**APPLICATION FOR PERMISSION UNDER SECTION 16 TOWN PLANNING  
APPLICATION FOR PROPOSED MINOR RELAXATION OF PLOT RATIO RESTRICTION  
FOR PERMITTED FLAT WITH SHOP AND SERVICES AND SOCIAL WELFARE  
FACILITY (RESIDENTIAL CARE HOME(S) FOR THE ELDERLY) IN "RESIDENTIAL  
(GROUP A)" ZONE IN LOT NO. 3678 in D.D. 120, YUEN LONG, NEW TERRITORIES**

**Town Planning Application No. A/YL/319 – Submission of Further Information**

**Proposed Minor Relaxation of Plot Ratio Restriction for Permitted Flat with Shop and Services and Social Welfare Facility (Residential Care Home for the Elderly) Uses in “Residential (Group A)” Zone at Lot 3678 in D.D. 120, Yuen Long, New Territories (Application No. A/YL/319)**

**FIGURE 2.4**  
**LOCATION OF CARPARK AND KITCHEN**  
**EXHAUST**

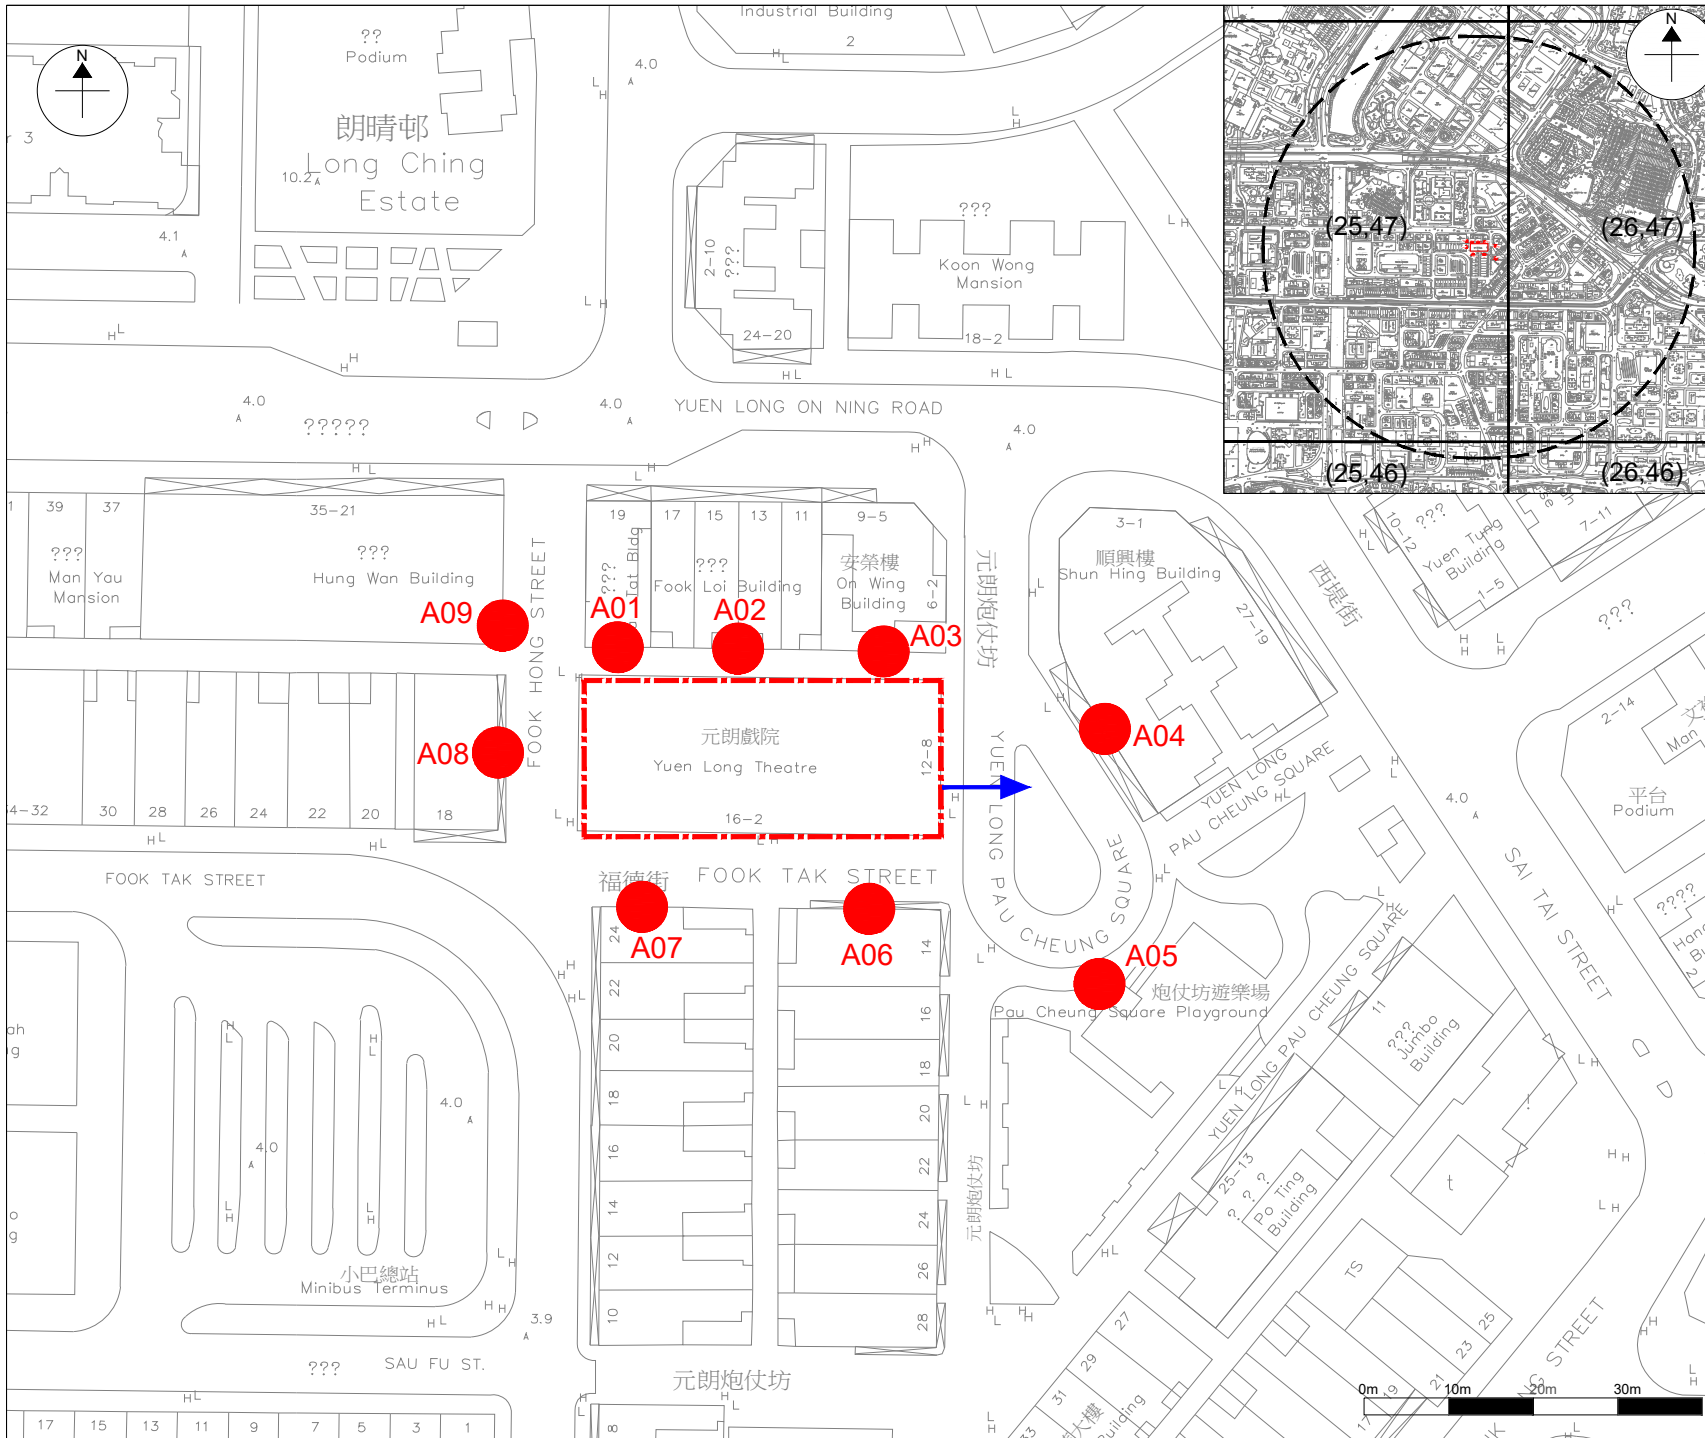
| <p>i) Sections 2.6.5 and 2.6.6 – Please show the potential locations of the exhaust for the proposed underground carpark and kitchen in a map to demonstrate that these exhausts will be located away from all nearby ASRs.</p>   | <p>The potential locations of the exhaust for the proposed underground carpark and kitchen are provided in Figure 2.4 of the Revised Environmental Assessment Report (<b>Attachment 3</b>).</p>  |

**FIGURE 3.4**  
**LINE OF SIGHT FROM PROPOSED**  
**DEVELOPMENT TO TML**

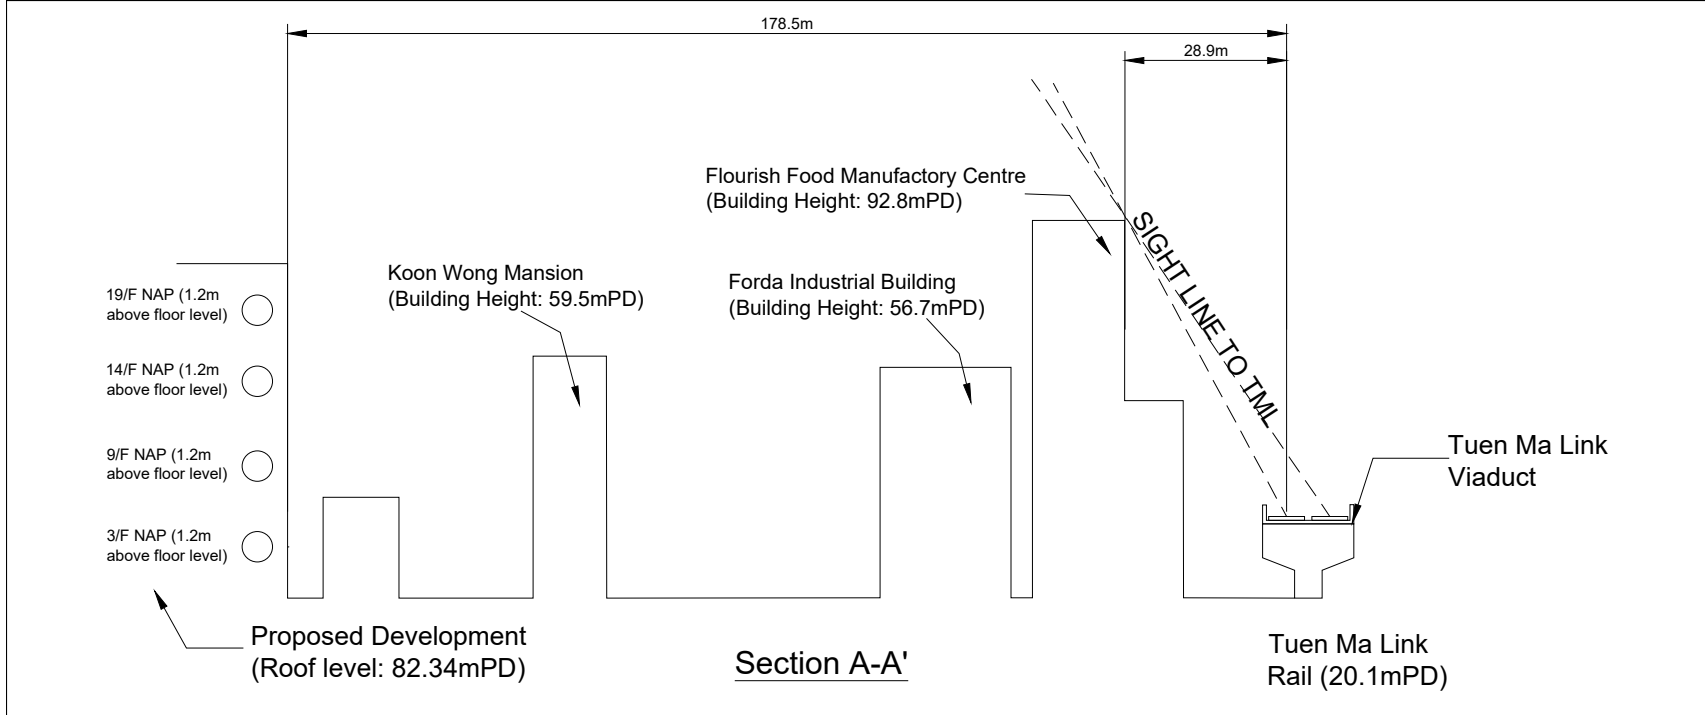
| <p>a) Based on the desktop review, the Tuen Ma Link (TML) viaduct is located approximately 100m to the north and northeast of the site. It is noted that the viaduct of TML might be obstructed by surrounding building structures, and hence, there is no direct line of sight to the planned NSRs. Thus, no adverse railway noise impact is anticipated. Still, the consultant should conduct a qualitative railway noise impact assessment to address the associated railway noise impact for completeness.</p> | <p>A qualitative railway noise impact assessment is provided in Section 3.6.13 – 3.6.15 of the Revised Environmental Assessment Report (<b>Attachment 3</b>).</p>   |
